DRAFT GENERIC TECHNICAL POSITION ON  
GROUNDWATER TRAVEL TIME (GWTT)  
by Richard Codell, Hydrology Section,  
Geotechnical Branch, DWM, NMSS  
May 14, 1986

DWM TECHNICAL POSITION  
ON GROUNDWATER TRAVEL TIME

Hydrology Detailed Comment Resolution Form

Figure 5 - Variance of Groundwater Travel Time Distribution

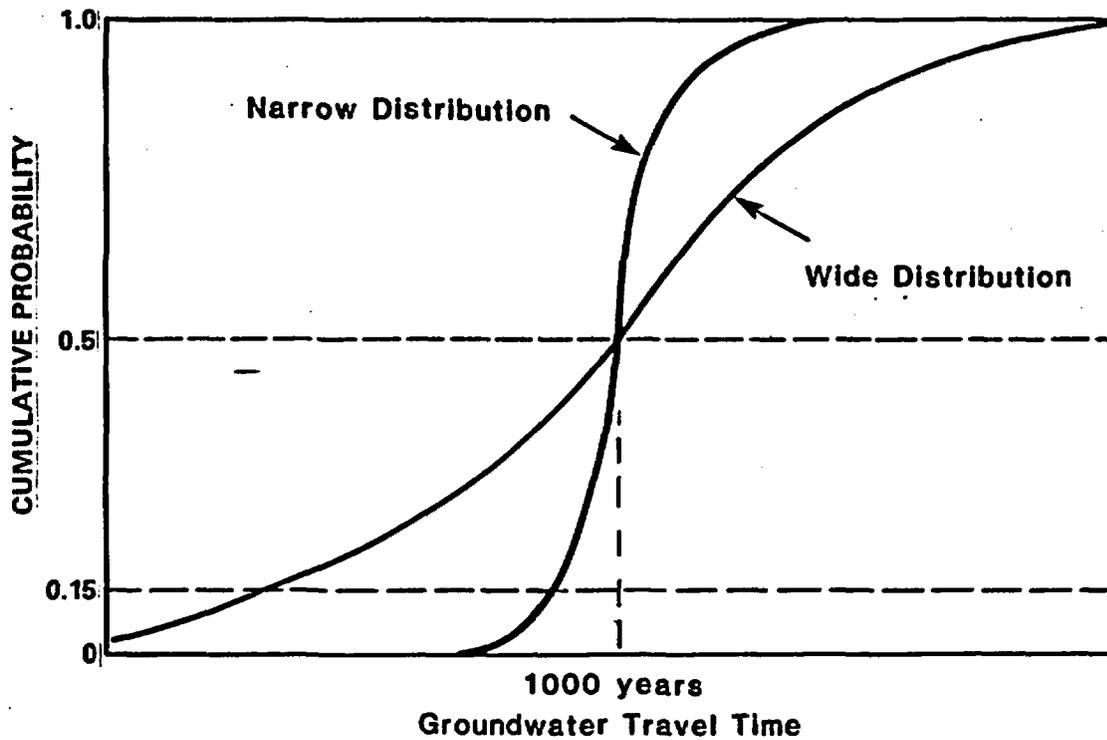
A choice for the percentile which is too high, say the median, would be undesirable because it may be insensitive to the variance of the GWTT distribution. This <sup>can</sup> be demonstrated for the hypothetical example depicted in Fig. 5. The two CDF curves of GWTT in this figure have the same median of 1000 years, but different variances. They may, for example, represent different sites. The curves may also represent a single site for which the data have no experimental bias, but at different points in the site characterization process. Under the median GWTT criterion, sites which exhibit a wide variance of the travel time distribution for reasons such as great spatial variability, an inadequate conceptual model, inadequate drill and test plan, or measurement uncertainty, would be treated as equals. A smaller percentile justifiably favors the site which has the smaller variance in the GWTT distribution. If the wider variance is due to quantifiable uncertainty (e.g., lack of data), the smaller percentile would serve as an incentive to further characterize the site. A smaller percentile favors the site which has the smaller variance in the GWTT distribution.
